**PLANNED UNIT DEVELOPMENT &  
PLANNING APPROVAL STAFF REPORT****Date: June 4, 2009****NAME**

ICM Foundation

1007 Government Street  
(Southeast corner of Government Street and Chatham  
Street, extending to the North side of Church Street, 100'±  
East of Chatham Street)

Planning Approval to allow a church in an R-1, Single-  
Family Residential District, and Planned Unit Development  
Approval to allow multiple buildings on a single building  
site.

# SITE PLAN

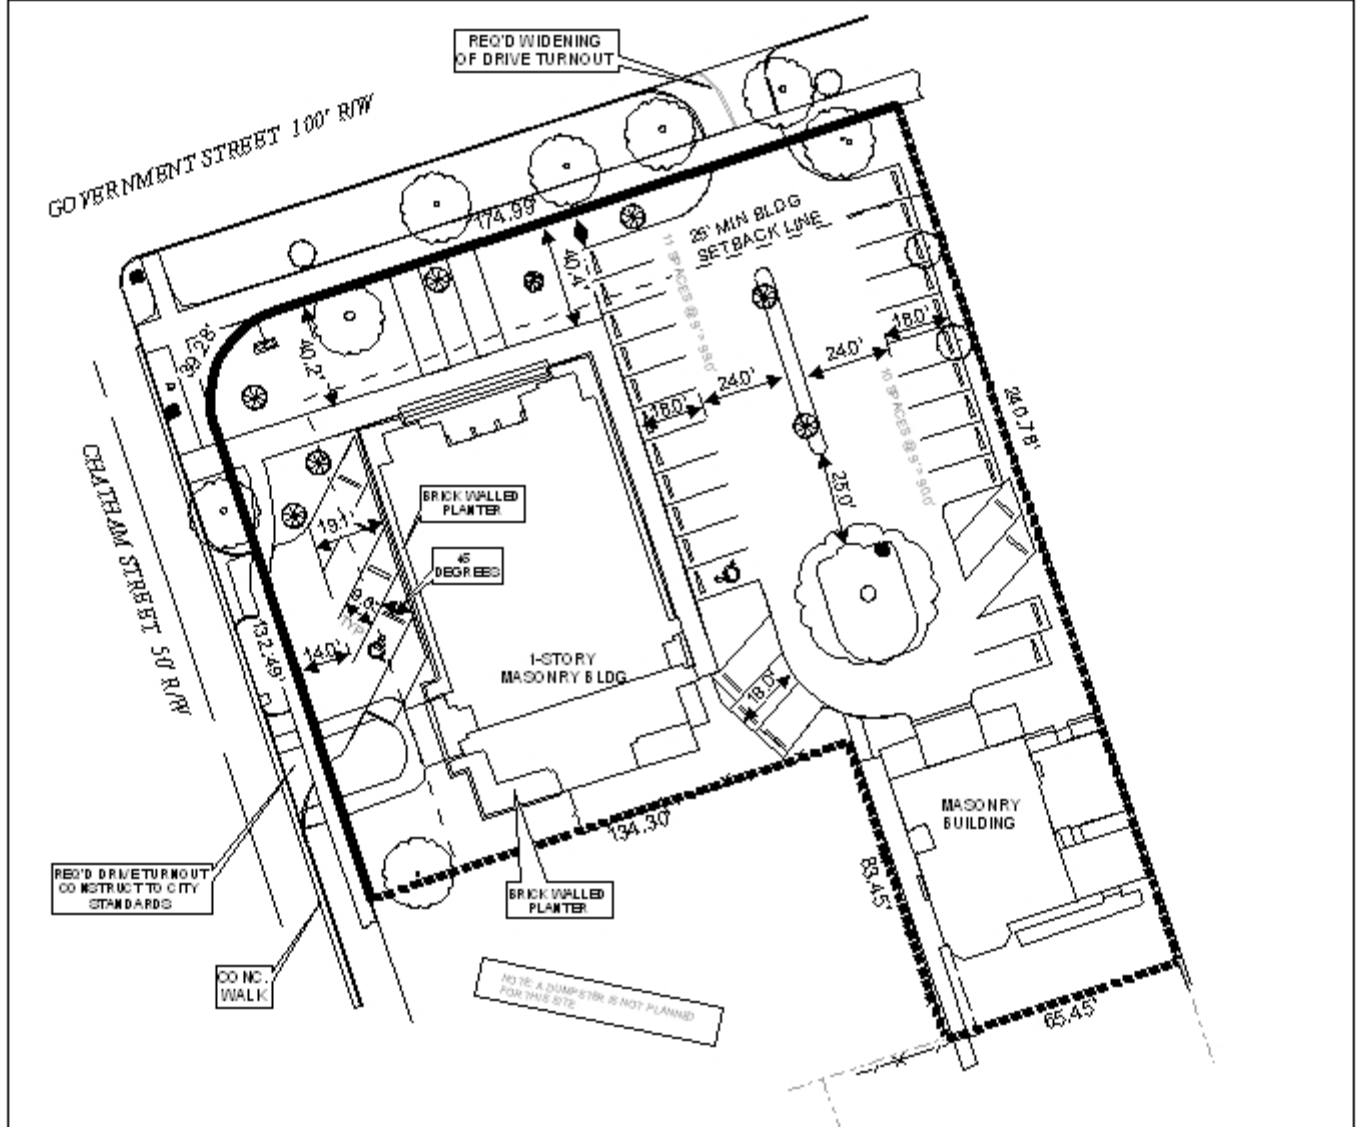
Driveway number, size, location, and design to be  
approved by Traffic Engineering and ALDOT and conform to AASHTO standards. Minimum  
parking aisle width for the angled parking is eighteen feet. One-way drives should be signed and  
marked. Standard width for a two-way drive is twenty-four feet. The parking aisle width  
becomes too narrow at the south end of the parking lot. Eighteen feet of aisle width would be  
more appropriate for this area.

The applicant also proposes to provide parking to accommodate 32 vehicles, as no designated parking is currently provided on the property. The applicant is proposing concrete block pavers that allow grass to grow within a concrete-bounded grid – this alternative parking surface will require an application to the Board of Zoning Adjustment, as such parking surfaces are only allowed “by-right” as overflow parking. An application to the Architectural Review Board may also be necessary due to its location in the Oakleigh Garden Historic District.

The proposed parking area will be divided into two parts: 4 spaces will be provided on the West side of the church, requiring two new curb-cuts onto Chatham Street, with 28 spaces provided on the East side of the church, with a widened curb-cut onto Government Street. Currently, parking on the site occurs on the East side, on grass, utilizing a residential width curb-cut onto Government Street. The proposed widening of the curb-cut onto Government Street is limited by two existing live oak trees. The East side parking area is proposed to incorporate an existing 96-inch DBH live oak tree, that has a canopy width estimated to be 115 feet across. The applicant proposes providing some green space around the trunk, in addition to using the permeable pavers. The proposed parking area is designed to provide one-way traffic around the tree, thus providing access to the two story structure at the rear of the site. It is recommended that the 28-space parking facility be redesigned to provide one-way circulation and parking only, increasing the area dedicated to green space in the vicinity of the 96-inch oak, and providing parking bumpers around the green space area to ensure that there is no vehicular intrusion into greenspace areas. It is also recommended that the 4 spaces proposed on the West side of the church be eliminated, and that the variance request that will be necessary for the alternative paving surface also include a request to reduce the number of required parking spaces.

While the proposed parking area will be surfaced with permeable paving, compliance with the storm water regulations may be required. If a surface storm water detention facility will be provided, it should be depicted and labeled on the site plan.

A final note about the parking area. Any spaces provided for handicap parking and accessibility may need to be paved with asphalt, concrete, or solid pavers, as grass-pavers may not meet surfacing requirements of the Americans with Disability Act.

Regarding the tree and landscape plan, it appears that the site will be short 3 frontage trees along Chatham Street. If the proposed parking area along Chatham is removed, adequate room will be available to plant the required frontage trees.

Finally, where no buffering exists between the site and adjacent residential properties, a 6-foot high wooden privacy fence should be provided. The locations for the buffer, identified by staff, are the property lines on the southern and southwestern boundaries of the lot, where the site abuts residences. No fence should be required within the 25-foot setback from Chatham Street, or along the eastern property line, where there is an existing masonry wall.

- 4) Revision of the site plan to eliminate parking and access proposed on the West side of the church, from Chatham Street;
- 5) Revision of the site plan to depict all parking and circulation as one way, on the East side of the church, maximizing to the greatest extent possible greenspace area for the existing 96-inch live oak;

- 6) Revision of the site plan to depict parking bumpers, curbing or other method of prevent vehicular traffic onto greenspace areas;
- 7) Revision of the site plan to depict and label a 6-foot high wooden privacy fence along the southern and southwestern property lines, where the site abuts existing residences, with no fence required within the 25-foot setback from Chatham Street or along the eastern boundary of the site;

- 9) Compliance with the tree and landscaping requirements of the Zoning Ordinance, including the addition of 3 frontage trees on the Chatham Street side;
